PROJECT
DWELLING EXTN / ALT
WEST BAY, LOCHMARA BAY
DRAWING
SITE LAYOUT

Subject: Request for Further Information – U120390 – West Bay, Lochmara
Our ref: 3503

Encl Drawings:
3503-C01 Site Layout
3503-C02 Cross Sections
3503-C11 Trench and bed Details
3503-C12 Trench & Retaining wall
3503-C20 Cut off Trench

ISSUE	
REPORT	
DATE 2 JULY 2012	SCALE (A3) 1:250
DRAWN KL	REVISION C
APPROVED KS	DWG NO. 3503-C01

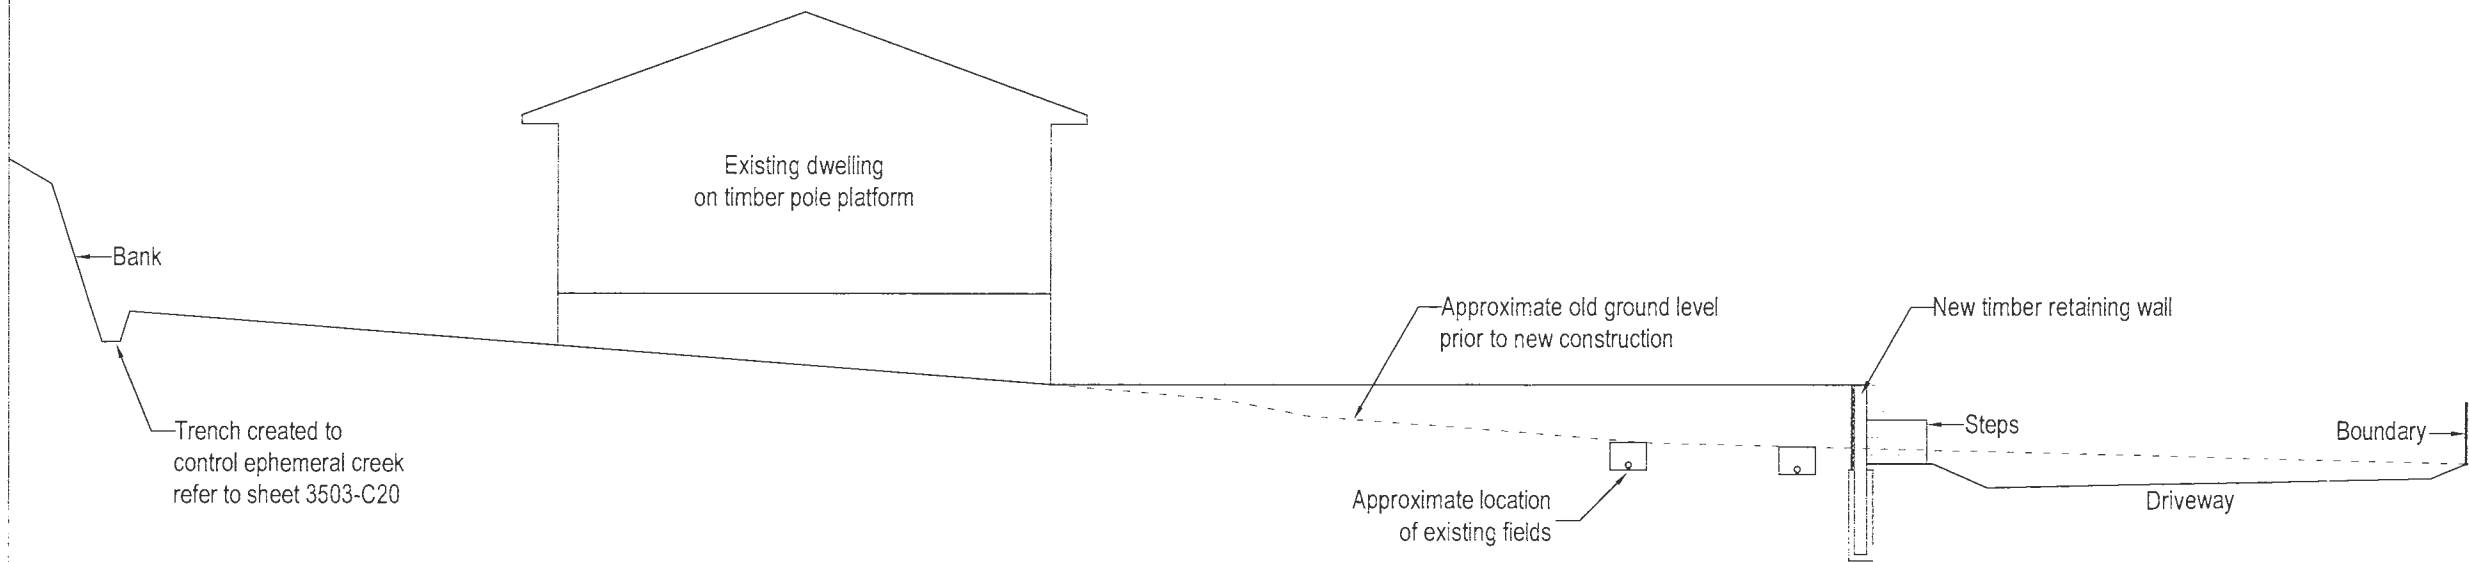
5. The cross section location is indicated on the revised site plan – Revision B, dated 6 September 2012 sent in with previous correspondence and shown with cross section markers labeled A. The attached revised cross section shows the information you request.

6. The site plan has been revised to show the driveway culverts and a cross section is attached.
7. There is no secondary flow path. There is another smaller culvert towards the end of the wall (and shown on the revised site plan drawing). If both culverts were blocked, it is expected to pond behind the retaining wall that has been built to form the road. If the road is overtopped the stormwater will cross the road and will re-enter the water course should the water get to that height (given the very small catchment size of around 0.5ha, this amount of ponding is very unlikely).

1 SECTION A-A
Scale 1:125

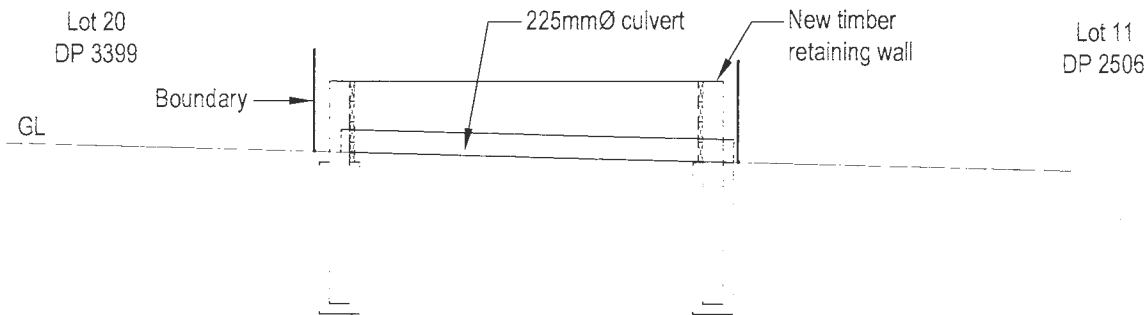
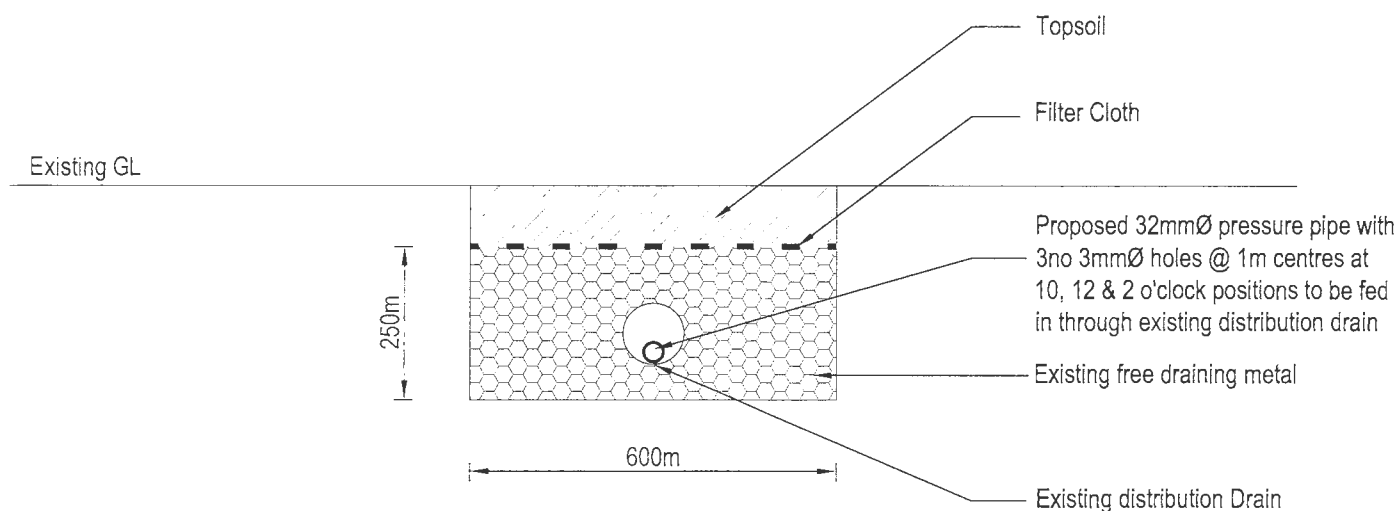
4. Please find attached the cross section you request. Please note the new field is 1m closer to the retaining wall than recommended in Table R1 of AS/NZS 1547:2012. Once again the guideline refers often to the regulatory authorities (the Marlborough District Council's) discretion. We have not received the updated Guidelines from the Council and have not been provided with any indication of minimum setbacks. Given the height of the retaining wall and the location of the field in relation to the existing ground we consider the 2m setback suitable in this instance. We also assume the Council finds this suitable as it was not identified in the request for additional information.

A 18.09.12 Existing ground and fields shown
